802.3dj D1.3 Comment Resolution Common Track

Matt Brown (Alphawave Semi), 802.3dj Chief Editor
Leon Bruckman, Nvidia
Jeff Slavick, Broadcom
Adee Ran, Cisco

- This slide package was assembled by the 802.3dj editorial team to provide background and detailed resolutions to aid in comment resolution.
- Specifically, these slides are for the various common track comments.

Figure 174A-4—Test configuration for a PHY using PCS counters

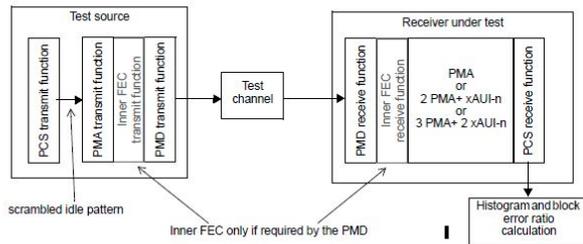
CI 174A	SC 174A.7.1.4	P 667	L 20	# 167
Bruckman, Leon		Nvidia		
Comment Type	TR	Comment Status	D	KER stress
It is not clear what is "stress" or where is it applied in the lane.				
Suggested Remedy				
In point a) change: "with no stress applied to any lane" to "with no stress applied to the receiver of any lane" InPoint b) change: "with stress applied only to lane i" to: "with stress applied only to the receiver of lane i"				
Proposed Response	Response Status W			
PROPOSED ACCEPT IN PRINCIPLE. Pending review of slides with topic "Block error ratio stress" in the following editorial contribution: <URL>/brown_3dj_03_2501

In addition to the concern expressed in the comment, the current wording does not tie in well with the histogram measurement method for $H_m(k)$ in the previous subclause nor is it clear what stress is to be applied. Also, clarify what each histogram represents.

- a) Measure the error histogram ~~$H_{mu}(k)$~~ $H_m(k)$ with no stress applied to the receive input on any lane and assign $H_m(k)$ to $H_{mu}(k)$. $H_{mu}(k)$ is the histogram with no stress applied to any receive input.
- b) Measure the error histogram ~~$H_{ms}(i)(k)$~~ $H_m(k)$ for each lane i with stress, as specified for the PMD or AUI component, applied only to the receive input on lane i and assign $H_m(k)$ to $H_{ms}(i)(k)$. $H_{ms}(i)(k)$ is the histogram with stress applied to the receive input on lane i .

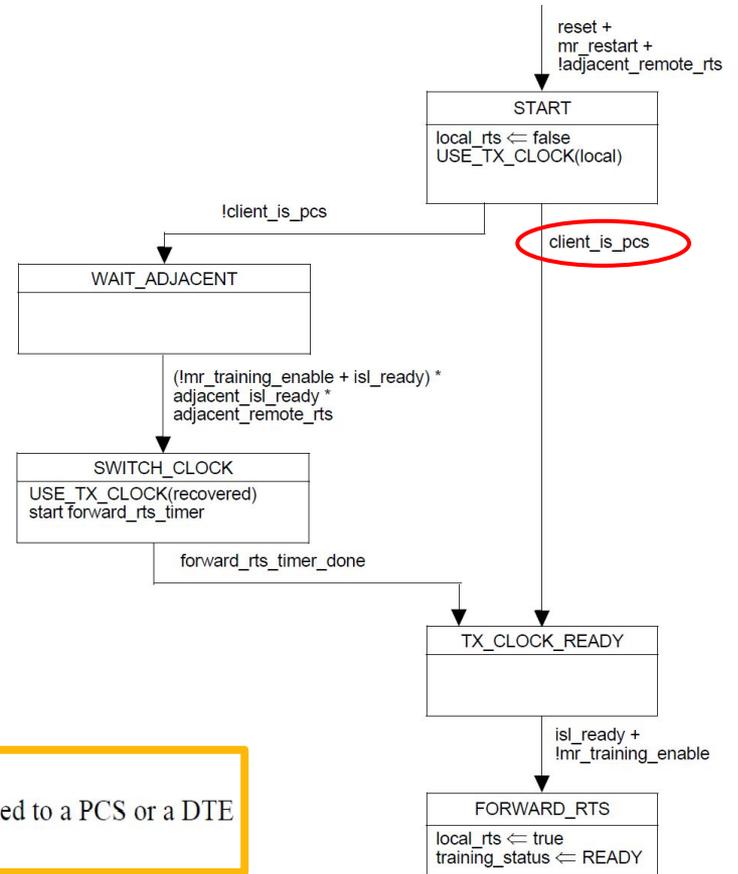
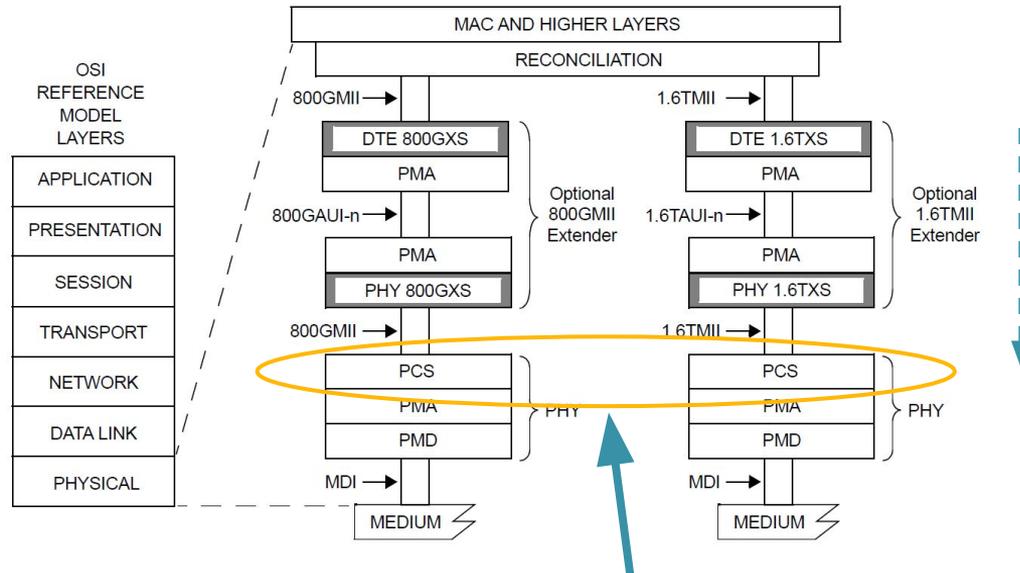
"other" interface is a bit ambiguous and the listed situations are the typical use case but does not cover all use cases. As a remote PCS (after a XS) could do either local or clock forwarding modes.

When tx_mode = DATA
the PCS transmit path may use the clock
recovered from the PMA above the XS
- or -
use local clock + rate adaptation (idles)

- The name of the variable should be a description of the effect, rather than an (incorrect) assumption of when it is set.
- Rename **client_is_pcs** to **uses_recovered_clock**
- Makes adjustments in the state diagram (logic inversion)

Rename client_is_pcs to be "uses_local_clock_only" and update the definition to be "Boolean variable that indicates if the PMA will never swap to a forwarded clock. For example this will be true for the first PMA below the RS."

Replace both uses of client_is_pcs with uses_local_clock_only in Fig 178B-7

- ACCEPT IN PRINCIPLE
- Rename “client_is_pcs” to “uses_recovered_clock” (logic inverse) and update the definition to be “Boolean variable set to true to indicate that the AUI component or PMD uses a clock recovered from another interface to drive its output when tx_mode = data. Otherwise it is set to false.”
- In Figure 178B-7 change:
 - “client_is_pcs” to “!uses_recovered_clock”
 - and “!client_is_pcs” to “uses_recovered_clock”
- Add MDIO variable to configure uses_recovered_clock

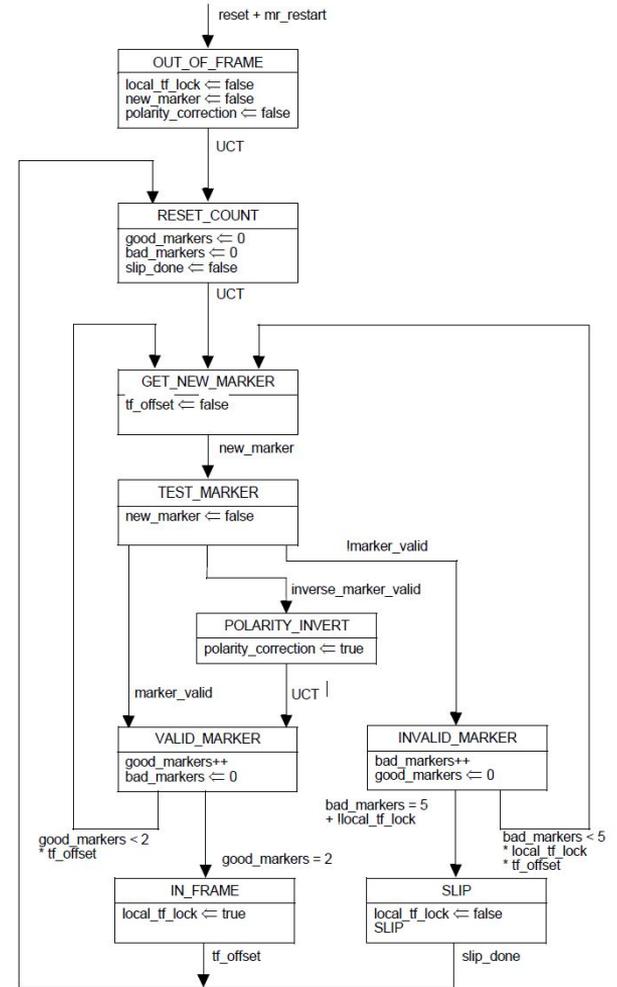
Fig 178B-9 needs to clarify the transitions out of TEST_MARKER.

Change the transition from TEST_MARKER to INVALID_MARKER to be "(!valid_marker * inverse_valid_marker) + (polarity_correction * inverse_valid_marker)"

Change the transition from TEST_MARKER to POLARITY_INVERT to be "!polarity_correction * inverse_marker_valid"

Proposed response – Option 2

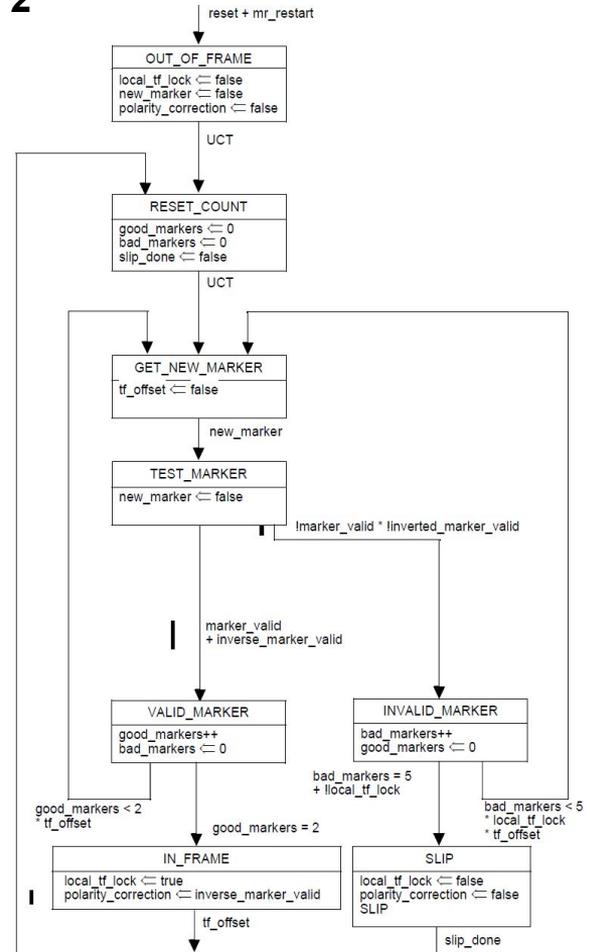
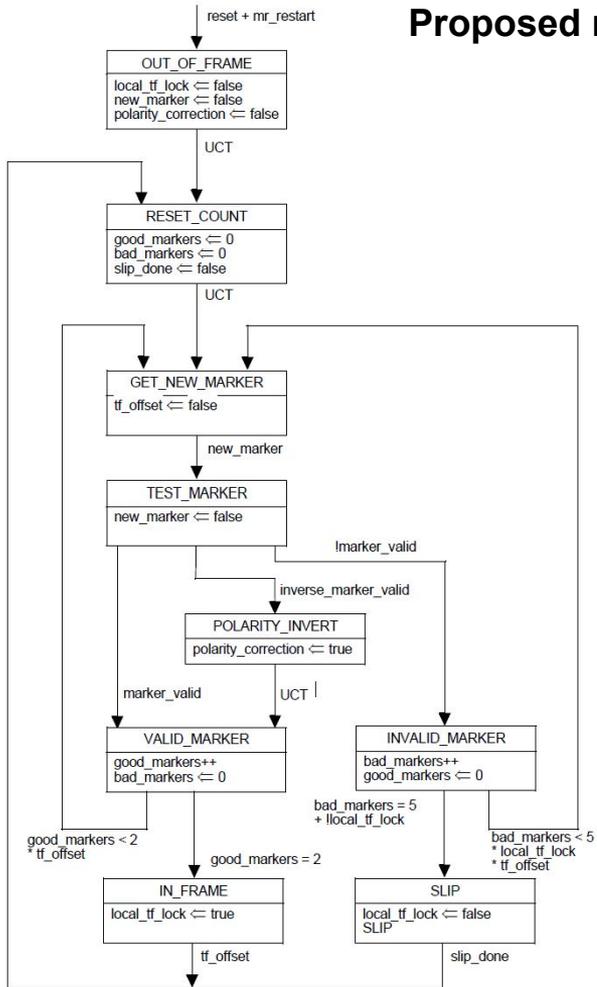
- Value of polarity_correction if one marker is inverted and the second marker is not (extremely low probability):
 - For option 1: polarity_correction = TRUE
 - For option 2: polarity_correction = FALSE
- Option 1 has minor changes compared to D1.3
- Option 2 puts the FSM back to the CI136 format but adds in the polarity invert functionality without adding states

- ACCEPT IN PRINCIPLE
- Replace Figure 178B-9 with the right figure in slide 5 of bruckman_dj_03_01_20_2025
- In 178B.14.3 page 786 line 35 (polarity_correction definition):
 - Change: “Boolean variable that is set to true when an inverted marker is detected. Otherwise it is set to false.”
 - To: “Boolean variable that is set to true when inverted **markers are detected upon acquiring training frame lock**. Otherwise it is set to false.”
- In 178B.10 page 779 line 43 (Polarity detection and correction):
 - Change: “The state of the polarity_correction variable persists until training restarts.”
 - To: “The state of the polarity_correction variable persists **after training completes, correcting the polarity of the data received when tx_mode is set to DATA.**”
